PLANNING BOARD AGENDA FOR SEPTEMBER 22, 2026 - 7:00 PM

1. **Tuscan Village Master Development Site Plan** – Conceptual Discussion on revised master plan for Tuscan Village to include 120-key hotel, 392 apartments, 72 workforce housing units, medical office, general office, bank, and restaurant uses at 14-24 Tuscan Blvd, Map 107, Lot 12605. Continued from 7/28/2026.

TUSCAN VILLAGE MASTER PLAN UPDATE

PARKING PLAN

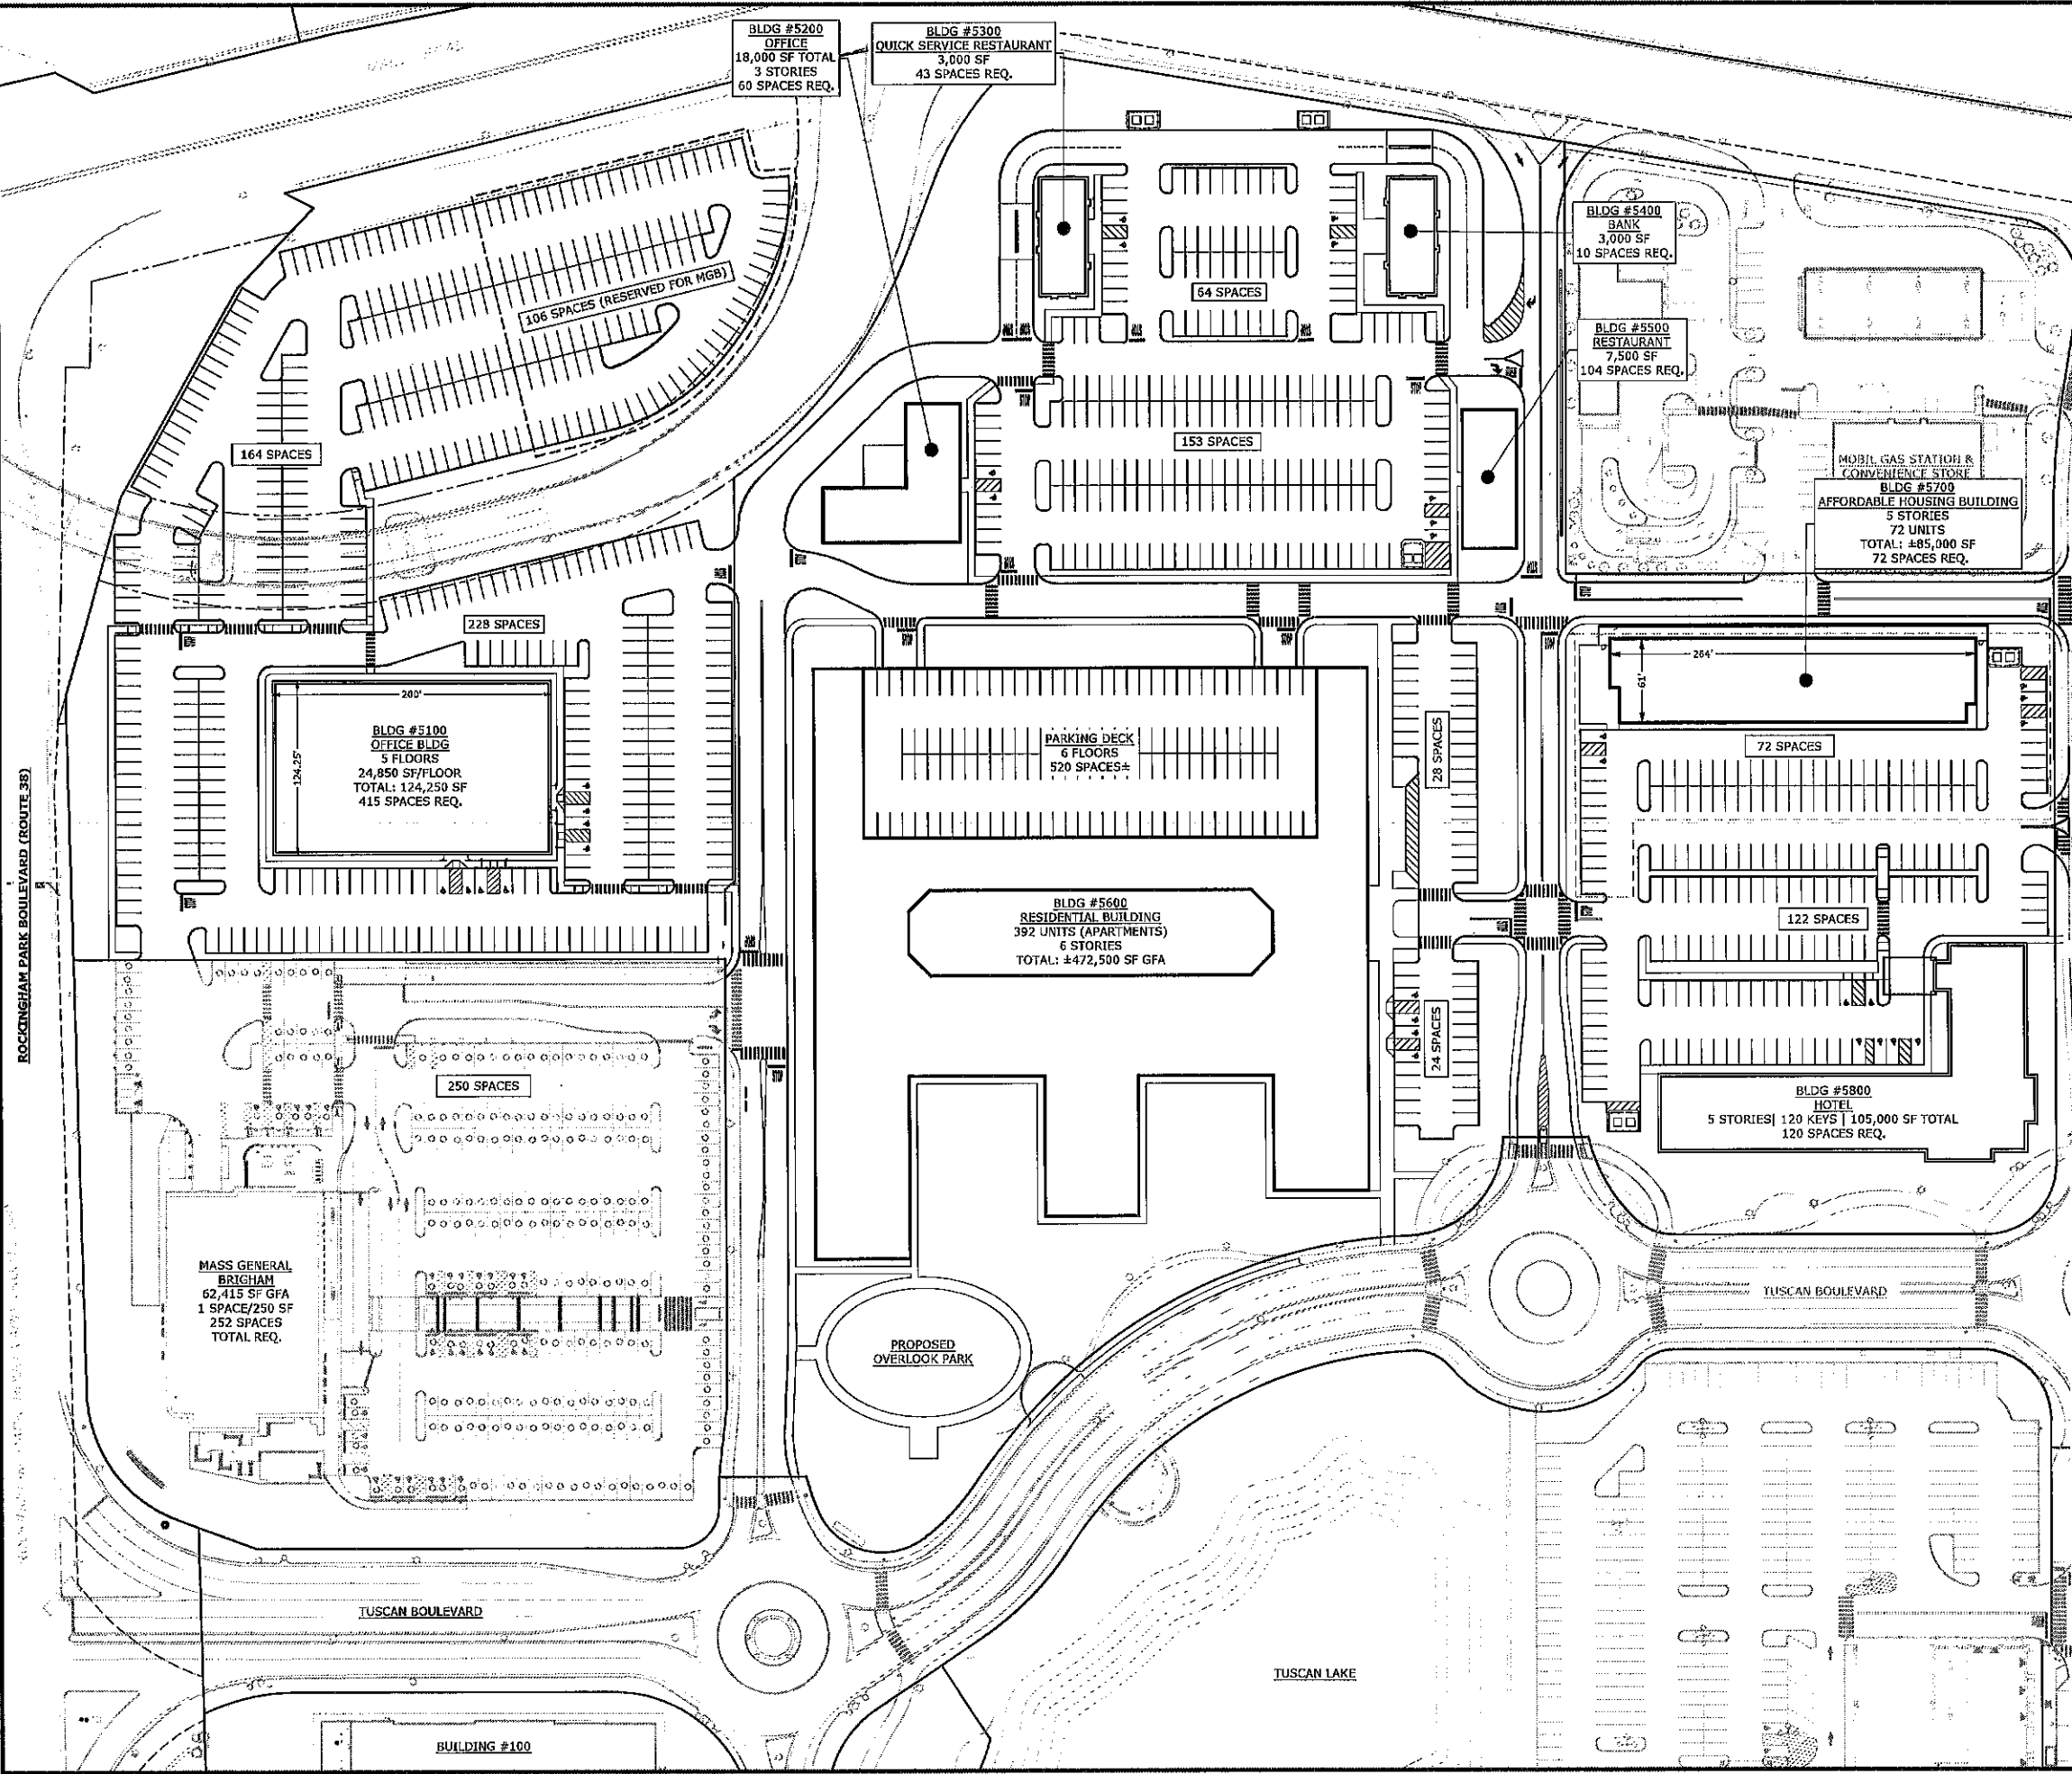
The Parking Plan (Sheet 6) indicates 4 accessible spaces for Building 5600 (condominiums) out of the 73 spaces in the surface lot. There is no indication of how many accessible spaces there are in the underground parking area (with 180 total spaces).

Sheet 6 also shows 2 accessible spaces opposite the middle of Building 5700 (workforce housing), plus four additional covered spaces on the first floor. It is unclear whether the covered spaces are dedicated to residents or whether they will be open and available to all.

Comment 16: *Accessible Parking - Building 5700: Sheet 6 shows 2 accessible spaces at the southern end plus three at the northern end of the workforce housing parking lot. This is a reduction by 1 accessible space from the June 2025 design, while the number of units increased by 22. There are no accessible walkways shown between the ADA parking spaces and the building entry. Concerningly, the spaces have been located 140-190 feet from the building entry, and are not compliant with the NH Building Code.*

Comment 47: *Additionally, there are several discrepancies between the parking space totals shown on the Parking Plan (Sheet 6) and the Parking Table Plan (Sheet 7). Building 5000 MGB Flyover Parking: 106 spaces reserved for the existing MGB building Building 5100 Office Building Flyover: short 22 or 23 parking spaces 398 provided Discrepancy: Parking Plan Sheet 6 requires 415 spaces Parking Table Plan Sheet 7 requires 414 spaces Building 5200 5500 Office Restaurant: short 11 parking spaces: 164 required, 153 provided Building 5300 5400 Fast Food Bank: +11 parking spaces (53 required, 64 provided) Building 5600 Apartments: 23 or +25 spaces reserved for only that building's use Discrepancy: Parking Plan Sheet 6 lists 572 spaces provided Parking Table Plan Sheet 7 lists 574 spaces provided Building 5700 Workforce Housing: exactly meets requirement: 72 spaces for 72 units Note: 5 of the 72 spaces are dedicated ADA parking, so if there are fewer than 5 residents in the building with ADA plates, there will not be sufficient parking for each unit. Building 5800 Hotel: +2 spaces (120 required, 122 provided) As shown above, the project is short by 20 to 21 parking spaces that are open to all users. This shortfall does not take into account the snow storage areas that are not shown on the plans, and are expected to reduce the number of available parking spaces within each parking lot during the winter.*
